# UNITED STATES PATENT AND TRADEMARK OFFICE

APPLICATION NO.	FILING DATE	FIRST NAMED INVENTOR	ATTORNEY DOCKET NO.	CONFIRMATION NO.
10/658,306	09/09/2003	Nancy L. Saxon	60,130-1626; 02MRA0440	2157
26096	7590	01/05/2006	EXAMINER	
CARLSON, GASKEY & OLDS, P.C. 400 WEST MAPLE ROAD SUITE 350 BIRMINGHAM, MI 48009			ILAN, RUTH	
			ART UNIT	PAPER NUMBER
			3616

**Office Action Summary**

## **DETAILED ACTION**

**Fig. 10**

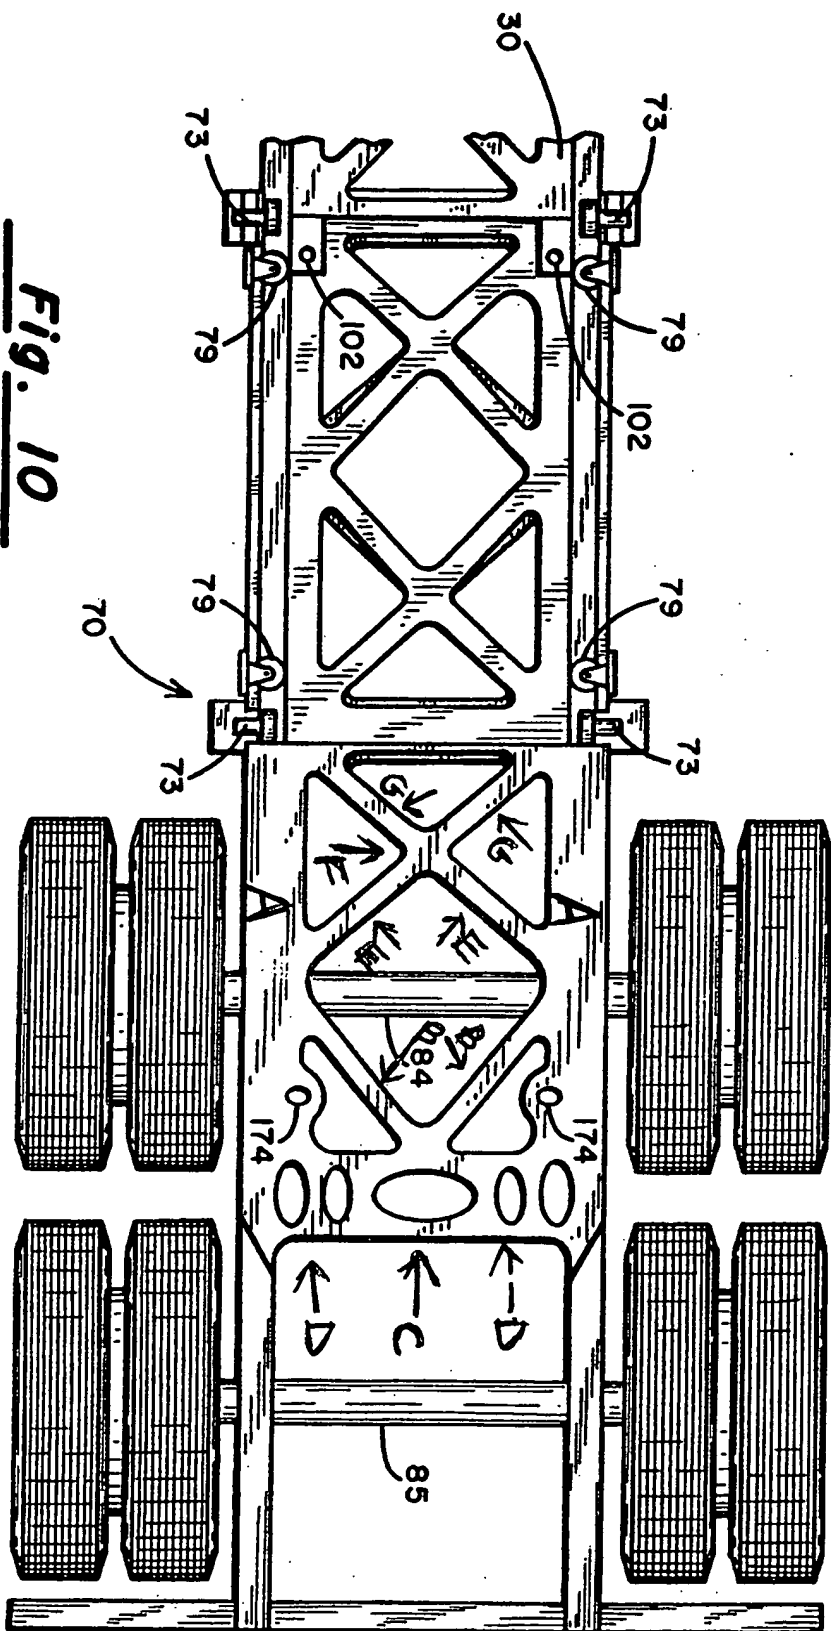
8. Claims 14, 16, 18, and 20 are rejected under 35 U.S.C. 102(b) as being anticipated by Christenson (US 5,067,740.) Please see the examiner annotated Figure 10 from Christenson. Christenson teaches a suspension slider (70) for a vehicle trailer (30) including first and second spaced apart longitudinal members (marked A in Figure 10) with a structure forming a continuous horizontal wall that interconnects the first and second longitudinal members and has first and second angled portions (B) converging to a central portion (C- portion of rear lateral member with central oval hole in it) and two lateral portions extending from the central portion (D- each of two sides of the lateral member with two oval holes each in them.) Regarding claim 20, third and fourth angled portions converge to a second central portion (F) and the second central portion has second lateral portions extending in opposing directions (G.)
